CCW IMPOUNDMENTS INSPECTION REPORT

GORGAS STEAM PLANT WALKER COUNTY, ALABAMA

**PROJECT NO. 09-4157
SEPTEMBER 2009**

**CCW IMPOUNDMENT ASSESSMENT REPORT
WILLIAM CRAWFORD GORGAS ELECTRIC
GENERATING PLANT
WALKER COUNTY, ALABAMA
PROJECT NO. 09-4157**

FIGURE 3
RATTLESNAKE DAM
AND FEATURES
GORGAS PLANT
DAM SAFETY INSPECTION
PREPARED FOR
USEPA
WASHINGTON, D.C.

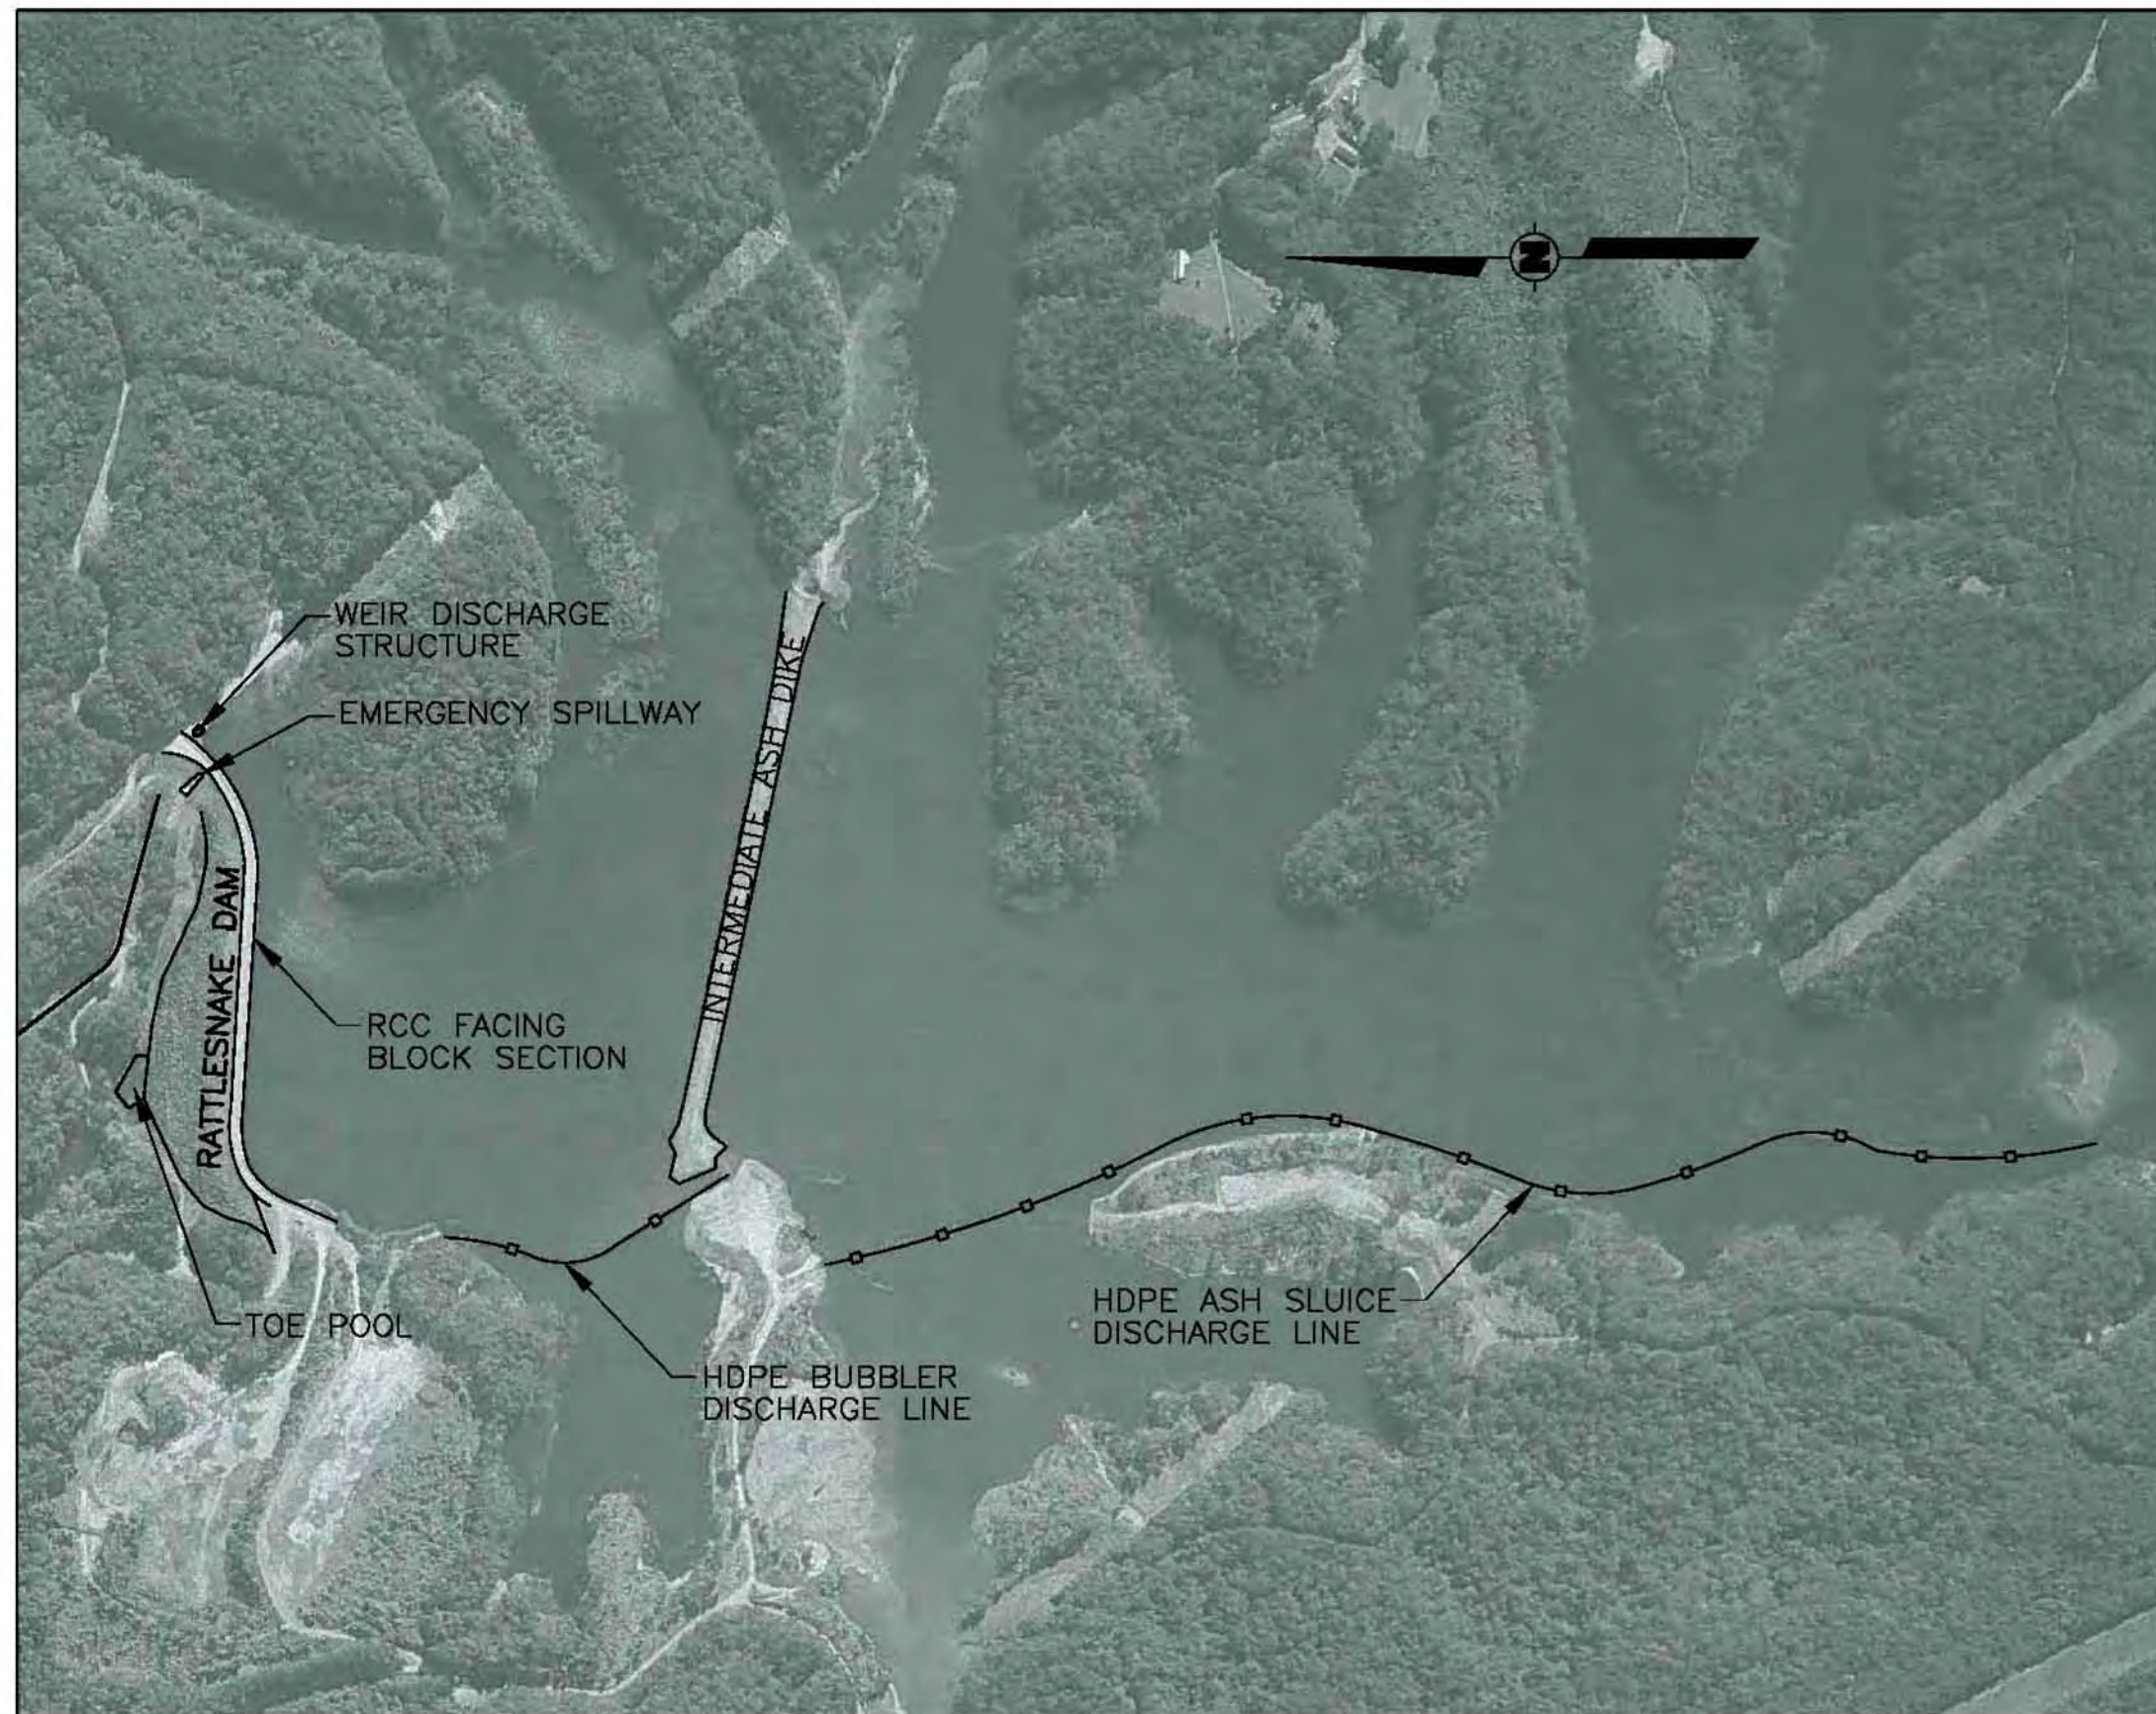
Vertical cracking was noted in the upstream face of the RCC near the intake weir and right abutment (*See Photo 6*). According to APC personnel, no construction joints were placed in the RCC facing between the abutments – a distance of approximately ^{redacted} feet. No area of concentrated vertical cracking was noted elsewhere on the RCC facing. The existing cracks should be monitored for change in size as part of the inspection program. The left abutment is flatter than the right abutment but may be subject to cracking due to future differential settlement. Observation of the front face of the RCC for cracking should be included in periodic inspection checklists.

The downstream toe is generally grassed and clear of trees and heavy vegetation, with the exception of areas of tall brush in areas difficult to reach with tractor mowers. Seepage was noted below the toe in the left abutment area. The area around the pond in the center portion of the dam appears to be continuously wet from seepage and tailwater from the river. The pond was built during the initial dam construction. Wet areas and standing

- LEGEND**
- ① APPROXIMATE LOCATION OF SEEPAGE FROM TOE.
 - ② CRACKING IN RCC FACING BLOCK NOTED HERE.

In conjunction with Recommendation No. 1, the existing weir box at the toe of the downstream slope of Rattlesnake Dam should be cleaned out and repositioned, or replaced with a larger weir if necessary, to collect the seepage flow along the downstream toe observed at the time of inspection. As much of the seepage currently visible should be collected as possible and the small ditch creating the current flow path should be kept as clear as possible to facilitate observations of changes in volume, turbidity, or location of new seeps. Such information, along with the flow measured at the box should be recorded as a part of Recommendation No. 1, so that seepage trends can be established and reviewed easily. In the event of increased seepage flows, the installation of additional instrumentation and a more involved monitoring program may be warranted.

It is recommended that cracks in the RCC facing block of Rattlesnake Dam be monitored as they develop, and that remedial measures such as caulking or grouting be considered to treat the cracks if they are deemed a risk to the embankment materials during normal conditions or high pool events.
